**GEORGETOWN-SCOTT COUNTY PLANNING COMMISSION
AGENDA**

**July 14, 2016
6:00 p.m.**

**Staff Report to the Georgetown-Scott County Planning Commission
July 14, 2016**

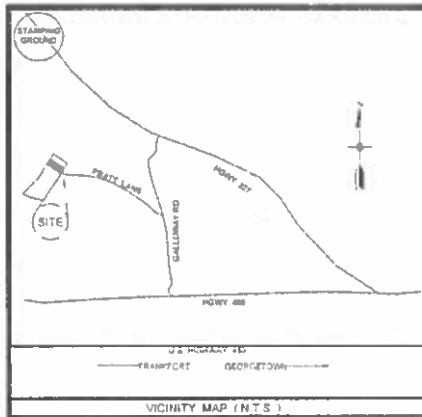
"In rural or unincorporated areas, all lots shall have either frontage on an existing public street, private street, or an approved access easement/driveway serving a maximum of three (3) lots. Such frontage or easement shall provide readily apparent physical means of access."

In order to meet the requirements of the *Subdivision and Development Regulations*, a section of the access easement will need to be brought up to county road standards. The section that will require improvements is the section of the access easement extending through where the first tract's driveway splits off from the access easement. This will require improvements for a distance of roughly 250 feet.

1. Any future subdivisions, revisions, or amendments to the approved subdivision plat must be reviewed and approved by the Planning Commission staff (minor) or by the Planning Commission (major).
2. All applicable requirements of the *Zoning Ordinance*.
3. All applicable requirements of the *Subdivision & Development Regulations*.
4. Prior to (as part of) the Final Subdivision Plat approval, the applicant shall provide the Planning Commission staff (GIS division) with a digital copy of the approved subdivision plat.
5. A portion of the access easement will need to be brought up to county road standards to ensure that only three (3) tracts are using an unimproved access easement. This improvement shall be completed prior to final plat approval.

PRELIMINARY DEVELOPMENT PLAN
CYRON HOLDINGS
106 BARKLEY LANE, GEORGETOWN, KY

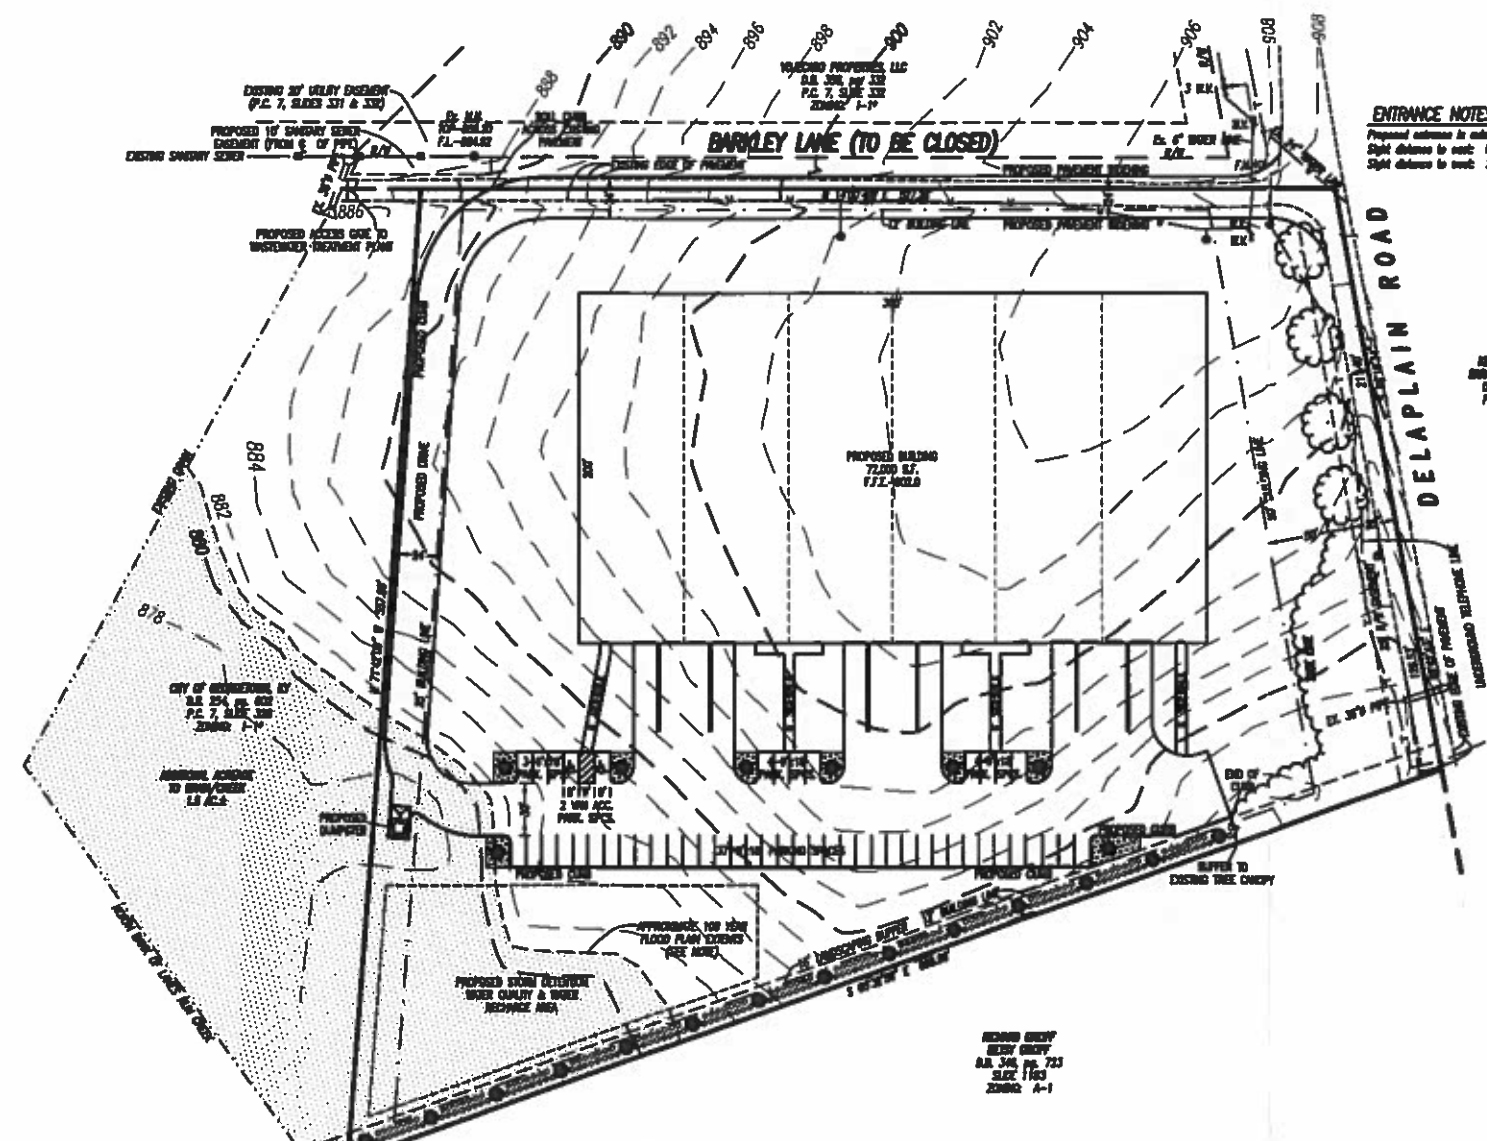
The *Landscape and Land Use Buffer Ordinance* requires a 15-foot wide Landscape Buffer Area along property boundaries adjoining agricultural land. At this time, the applicant has shown a landscape buffer along the adjoining property to the east. The adjoining property on the remaining three sides is zoned Industrial. There is floodplain on the southeast corner of the site following the north bank of Lanes Run Creek. There is a group of mature trees on the southeast corner of the site at the edge of the floodplain. It appears that these trees will need to be removed for the driveway. There is also a proposed dumpster shown in the floodplain in the area of this group of trees. It is recommended that the dumpster area be moved to get it out of the floodplain, that the applicants preserve the line of mature trees if possible and limit the amount of driveway in the floodplain.

The Applicant is showing interior landscaping and plantings in the employee parking areas. The Final Development Plan will be required to include a specie-specific landscape plan that meets the requirements of the *Landscape and Land Use Buffer Ordinance* and the *Subdivision and Development Regulations*.

Staff recommends **approval** of the Preliminary Development Plan for a 72,000 sf industrial building on 7.4 acres located southeast of the intersection of Barkley Lane and Delaplain Road, subject to the following conditions:

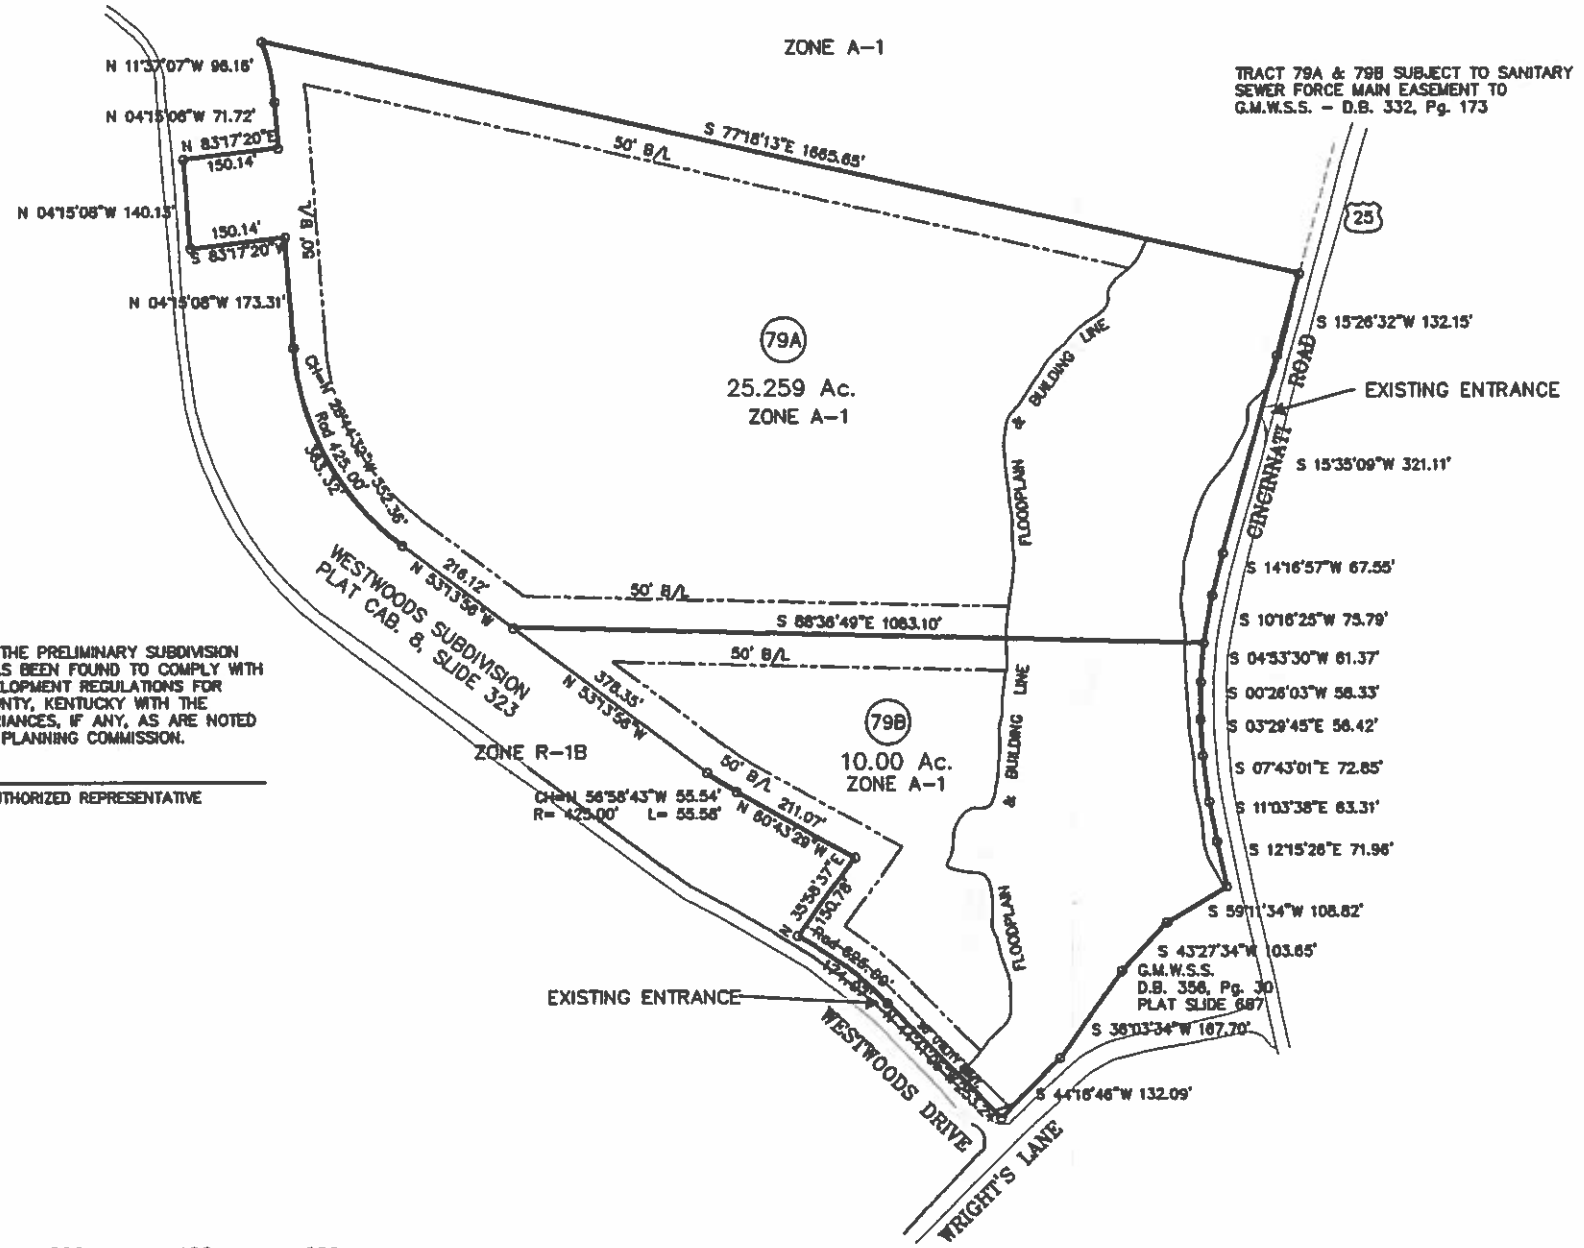
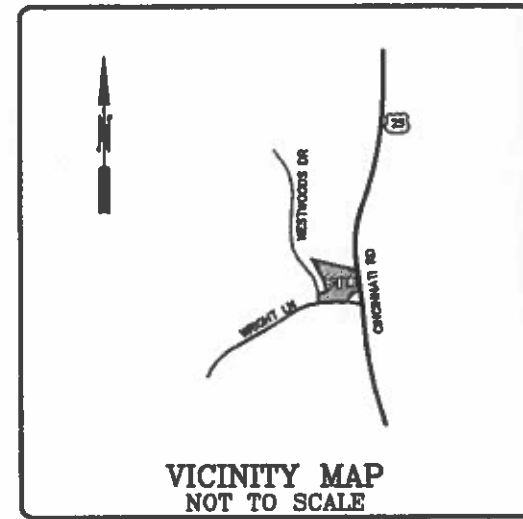
Sewage Disposal: The previous plats and staff reports indicate that all lots less than 5 acres within the Westwoods are to be served by the Mallard Point Disposal System (which has since been purchased by GMWSS). Currently, the plat shows a certification block for Health Department review of the sewage disposal system, rather than a signature block from GMWSS. The Applicant has indicated that the existing lot already has sewer connection, and that there is a preference for both lots to connect to the Mallard Point/GMWSS system. A GMWSS certification block will be added to the Final Plat.

Currently, a 3.985-acre park exists on the northern side of Westwoods Drive, between Lots 80 & 84. However, no trail system is indicated as suggested in previous case files. The staff reports indicate that a trail system was proposed around the R-1B zoned (urban-scaled) lots. Additionally, fencing on the plats has been shown to be located 10 feet off the residential lots. Perhaps this additional fencing setback was included to allow for pedestrian access of the trail, but it is not indicated as such on the plats. Staff recommends that the Planning Commission request additional information regarding the previously proposed trail system as it appeared an integral part of the zone change and preliminary plat discussions, but is no longer shown on the plats. The Commission should require that the pedestrian/walking trail be shown in an easement on Tracts 79A and 79B. It should also be considered whether it is appropriate to adjust the master plan and plat for all lots within the subdivision to show the trail system previously discussed as part of the Zone Change and Preliminary Subdivision Plats, although it may prove difficult as they are not indicated on the approved final plats.

1. Require Tracts 79A and 79B to connect to sanitary sewer line. Add certification block for GMWSS.
2. Provide a pedestrian/walking trail access easement along the western boundary of Tract 79A and 79B of 10 feet, to be located between the property boundary with the residential lots and the required buffer fencing.

3. Show required fencing along the western boundaries abutting residential lots.
4. Note existing KYTC and DOW permit numbers for existing entrance and creek crossing on the Final Plat.

5. Add a note to the Final Plat indicating accepted and approved agricultural related practices, Kentucky Right to Farm Act, and Kentucky Fence Law (see page 3 of staff report for sample).

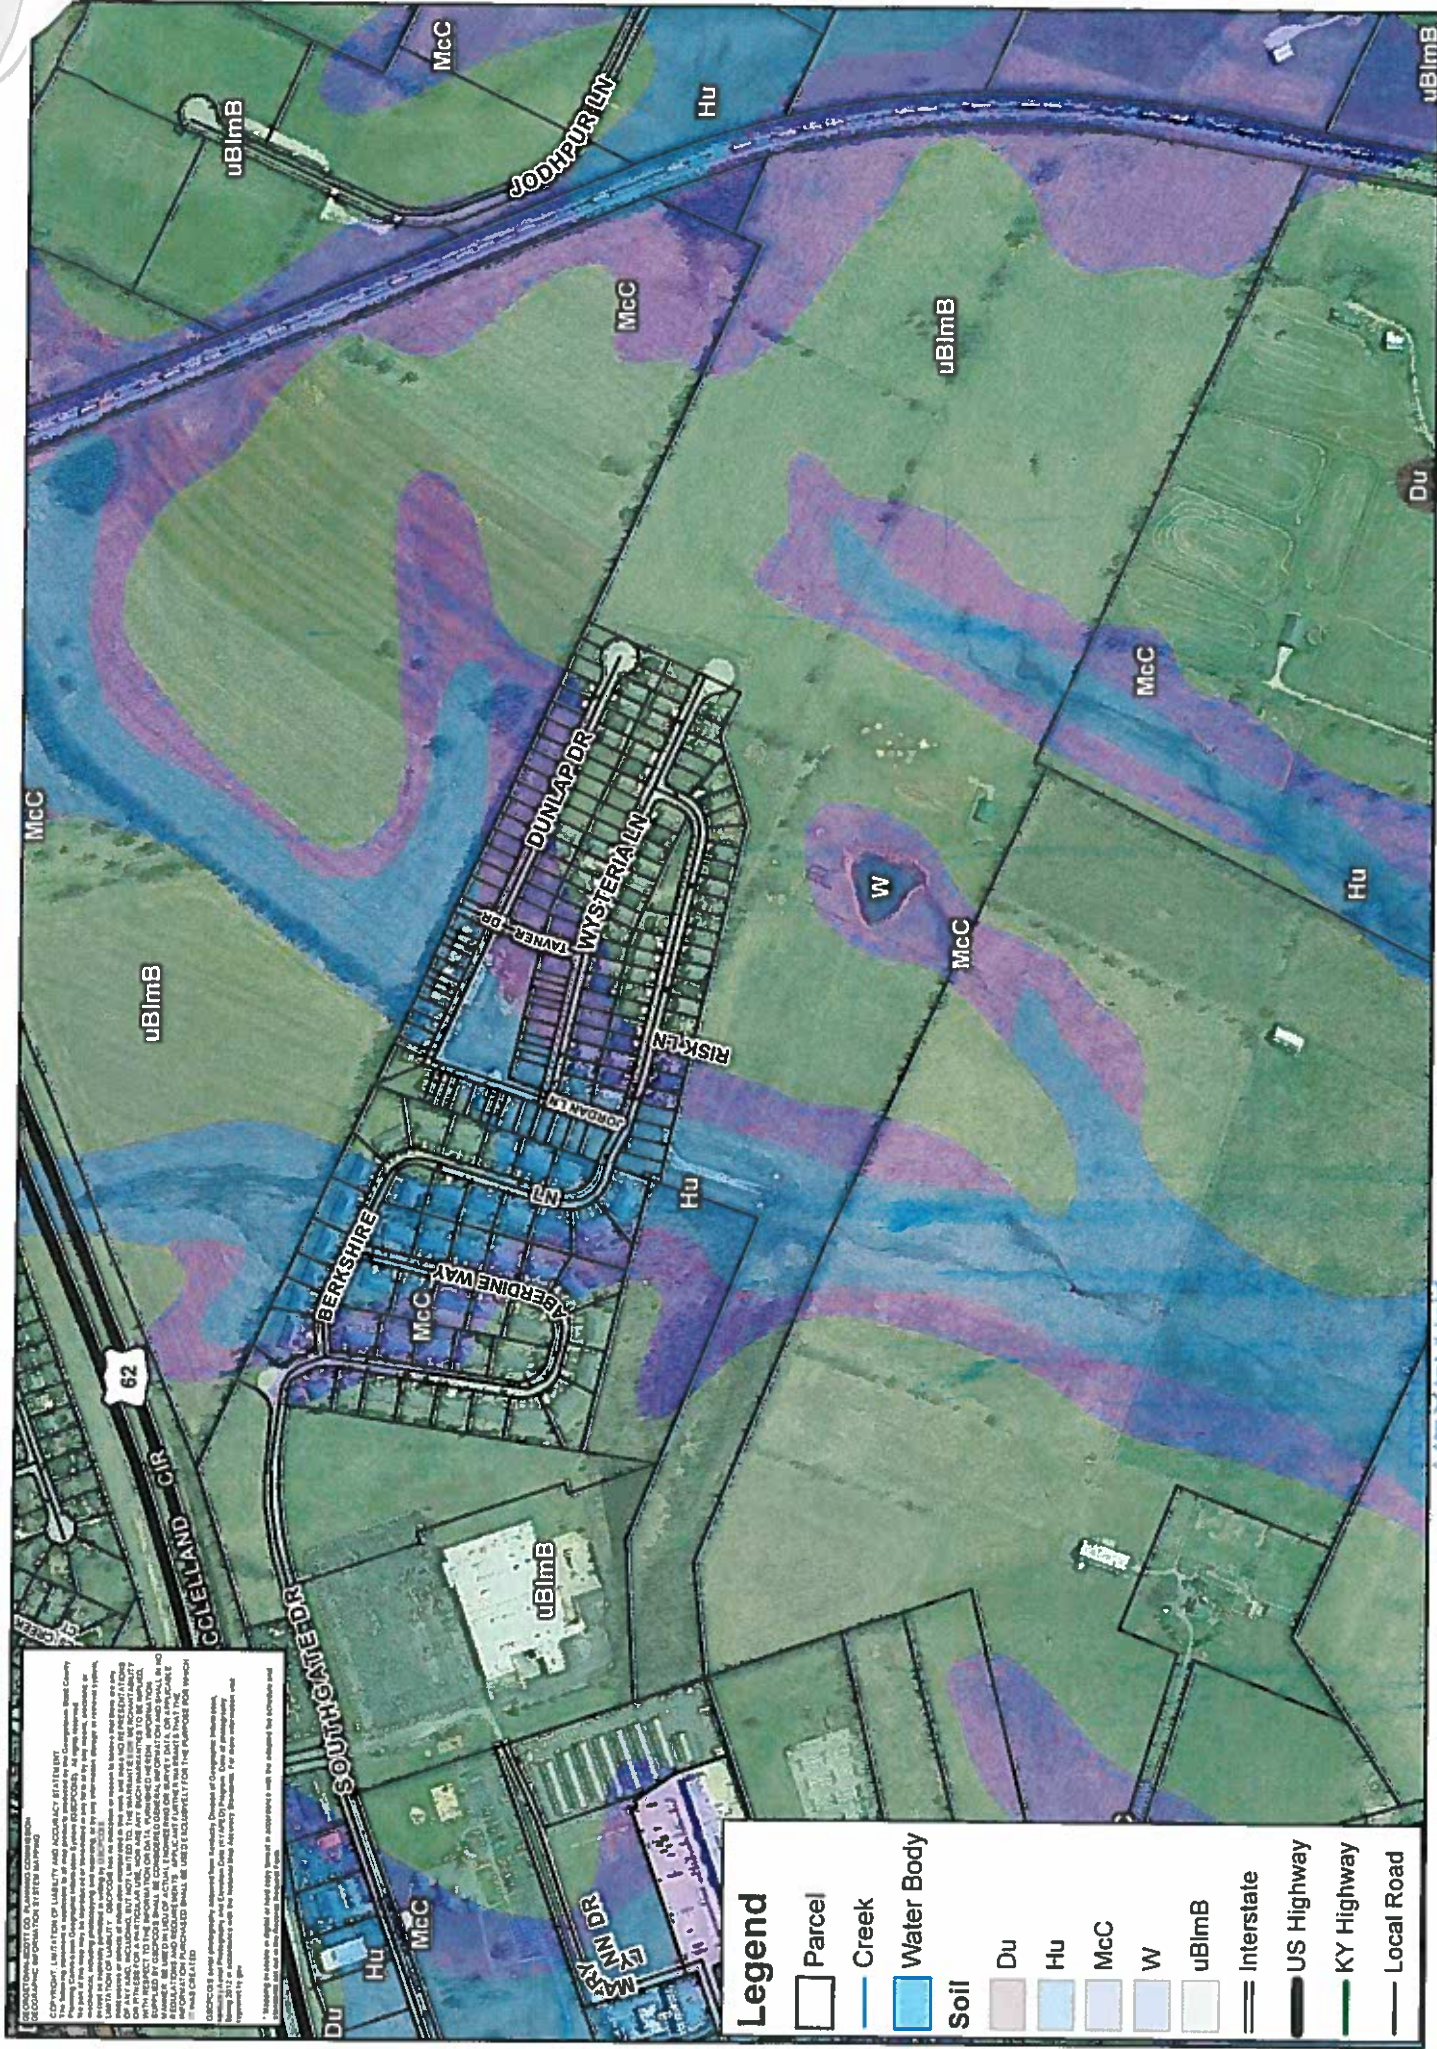
The applicant is also asking for preliminary approval of the proposed two subdivision plats. The first is a cluster subdivision with ten (10) cluster lots. The second is a rural subdivision with five (5) tracts between 5-10 acres in size accessed by a private access easement/driveway. The applicant, however, will first be required to obtain a zone change to A-5 (rural residential) prior to approval by the Planning Commission of the Preliminary Plat. The Planning Commission may review and approve the Preliminary Plat contingent upon zoning approval.

Approve the Preliminary Subdivision Plat for ten (10) residential cluster lots and one 38.55 acre preserved tract, subject to:

1. Zone Change being approved by Scott County Fiscal Court of Georgetown City Council, if applicable.
2. All requirements of the Scott County Health Department regarding onsite septic systems for 5-acre tracts. All requirements of GMWSS for cluster lots. Cluster lots shall utilize public sewer.
